**ROANOKE PLANNING AND ZONING AGENDA
AUGUST 15, 2022
7:00 PM**

SUBJECT: SUP 2022-06 - Townhomes on Morningside Drive

SUBJECT: Specific Use Permit (SUP 2022-06) Townhomes on Morningside Drive

SUBJECT: Site Plan (SP 2022-08) Prosperity Bank

① FRONT ELEVATION
1/8" = 1'-0"

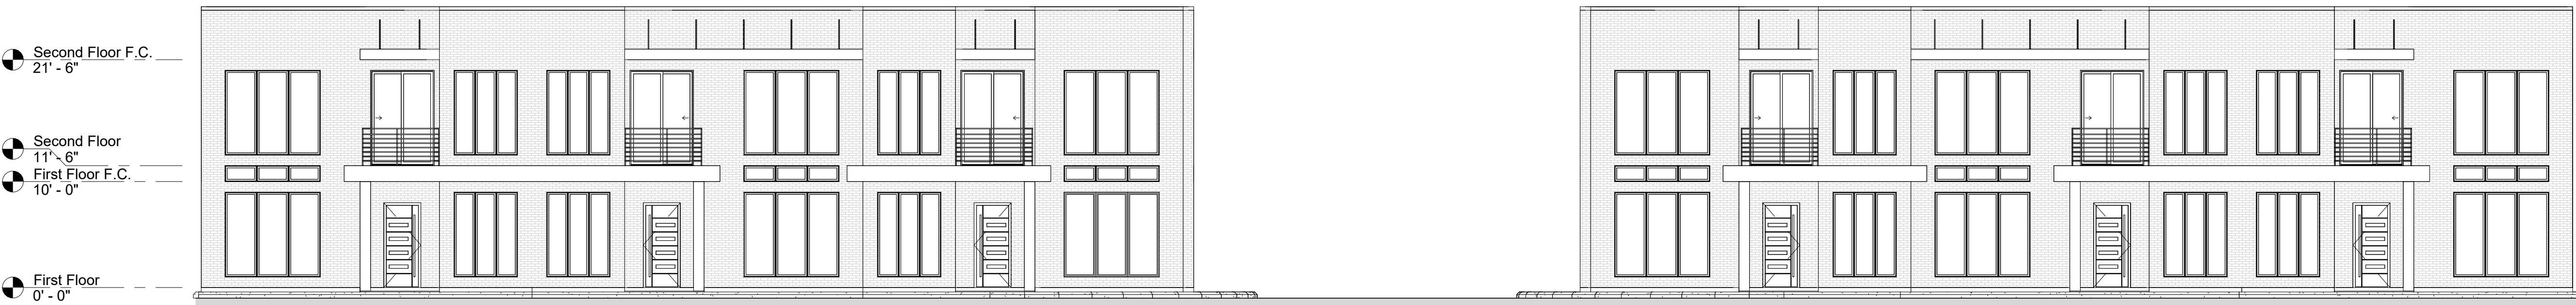
The proposed design of the buildings is not typical of the Oak Street Corridor design standards. The front facade offers a modern design that does not include architectural elements to achieve compatibility with the existing townhomes, which is a key design principle of the Oak Street Corridor Zoning District. The townhomes that were permitted in the Civic/Mixed Use zone on Morningside Drive and Crocket Street include character features that are compatible with the Oak Street Corridor Zoning District.

Staff recommends approval of the SUP with the condition that the front facade includes character features that are compatible with the Oak Street design standards as well as a street screen along the street frontage.
